## **Joint Inspection Report of 5 MLD STP Shuklaganj**

#### **A. I&D Structure-**

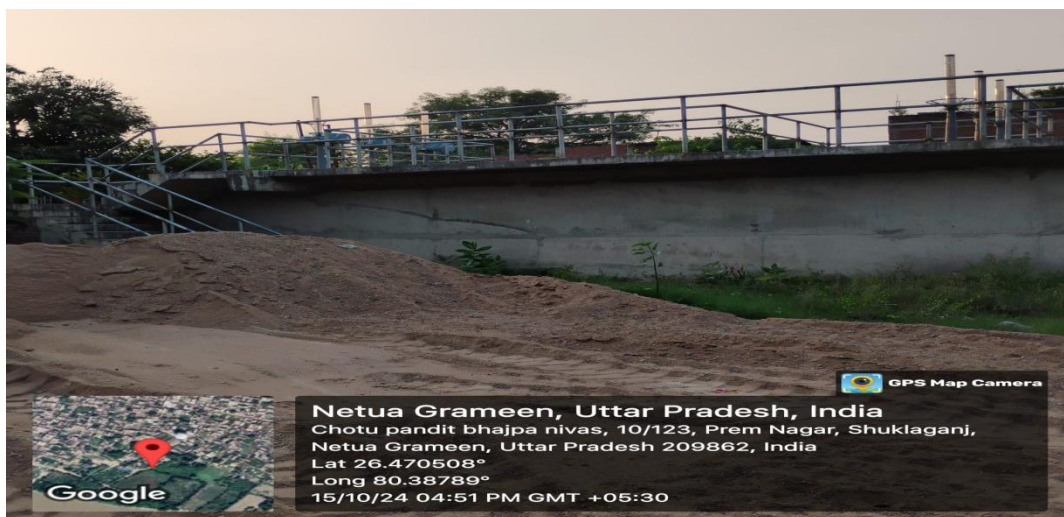
- i. Work of I&D structure is in progress. Reinforcement & shuttering work of wall is done. The casting of the all lift of the wall was done without informing UPJN and STC. In Approach channel, inlet channel and screen channel finishing and hydro test is pending.
- ii. During Site visit we found minor cracks are visible due to lack of curing.
- iii. Manual Screen's , Hand Rails are not installed.

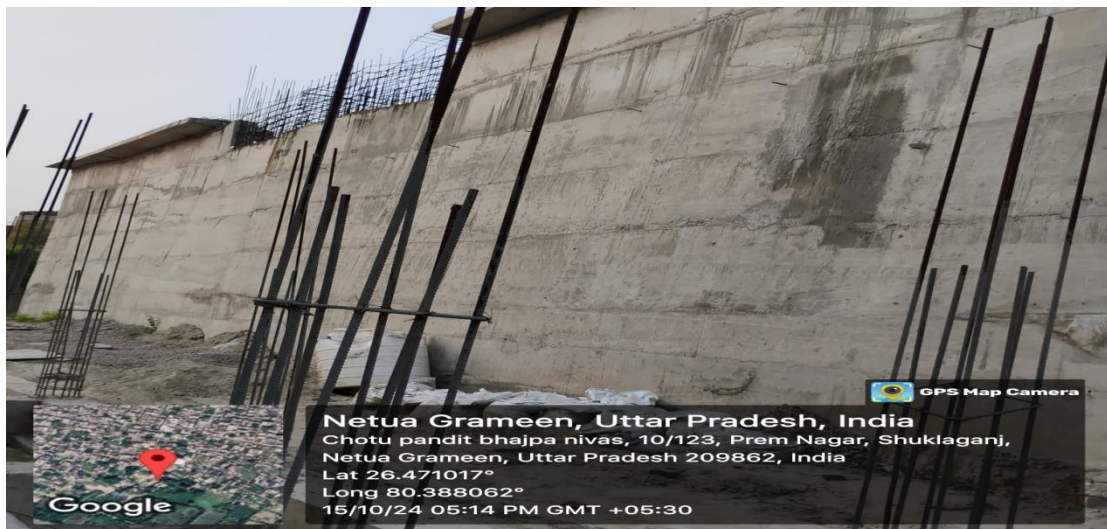
**C PTU-** Most of Steel found corroded. PTU, Column work completed and slab shuttering and reinforcement work is in progress. In Inlet chamber area finishing work, hydro test is pending. In Grit chamber and parshall flume RCC wall & slab, walk way, platform and hydro test pending. Stair casting done and connecting channel column on progress.

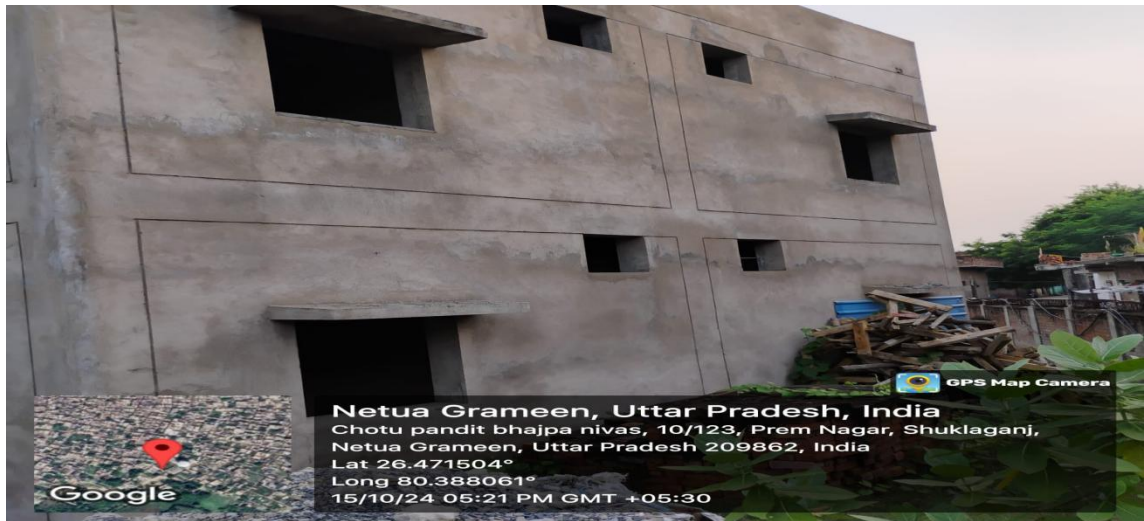
**Admin building cum Blower room-** In admin building room first floor and second floor slab work pending, brick work IPS flooring, electrification, sanitary fitting & plumbing, beam, column works are pending. In blower room roof slab, brick work, IPS flooring, roof treatment & finishing works are pending.
